INSERTION INSTRUCTIONS FOR AMENDMENT 3

NYSE&G PSAR

LIST OF EFFECTIVE PAGES
(Amendment 3, April 1979)

| <u>Figure</u> | <u>Title</u> |
|---------------|---|
| 7.1-2 | Compartmented Plant Protection System Equipment Arrangement |

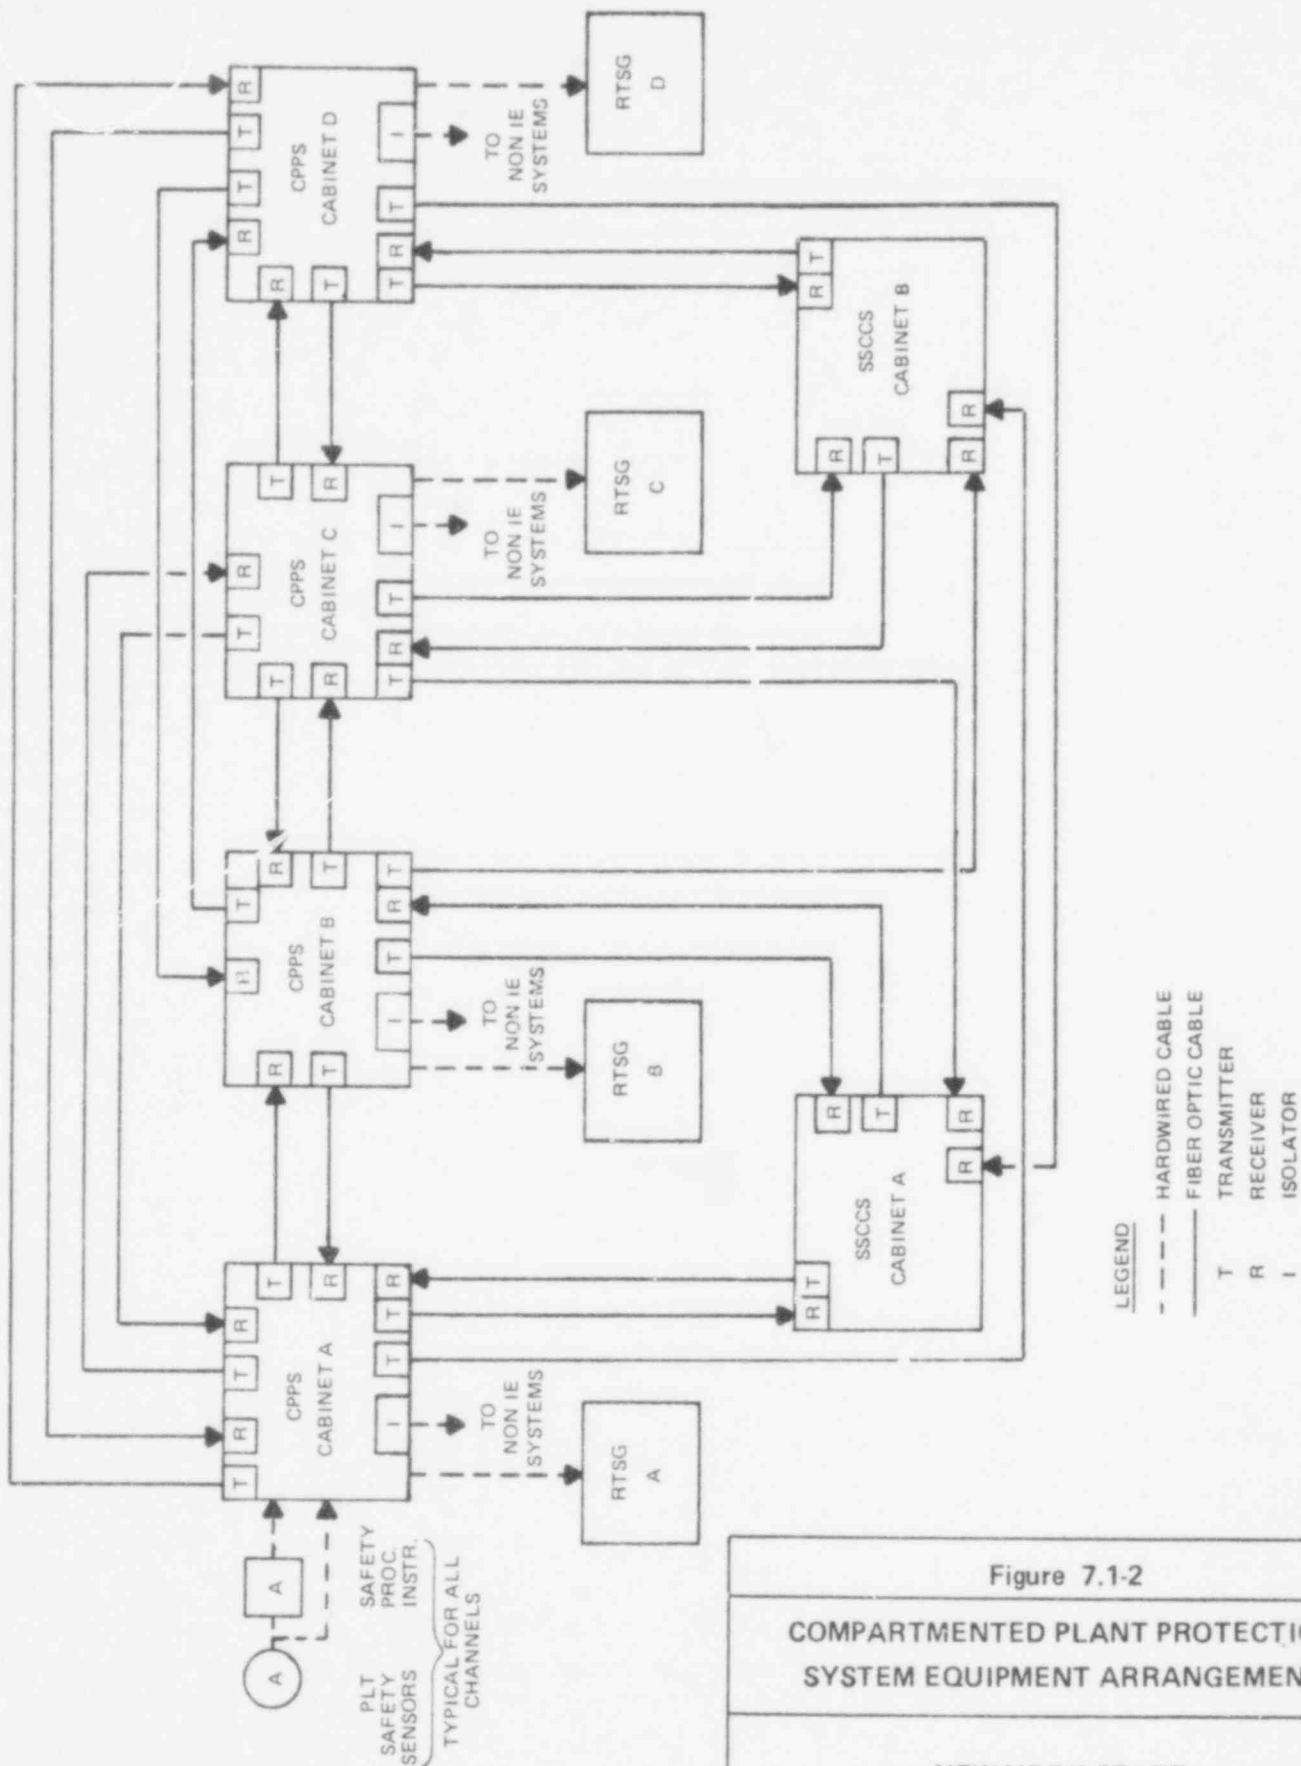
All four Compartmented Plant Protection System cabinets are interconnected by means of a fiber optic communication system, (as shown in Figure 7.1-2) which

consists of transmitters, receivers, and fiber optic cables. These cables provide inherent interchannel isolation and independence consistent with that achieved through the use of independent enclosures for each channel equipment.
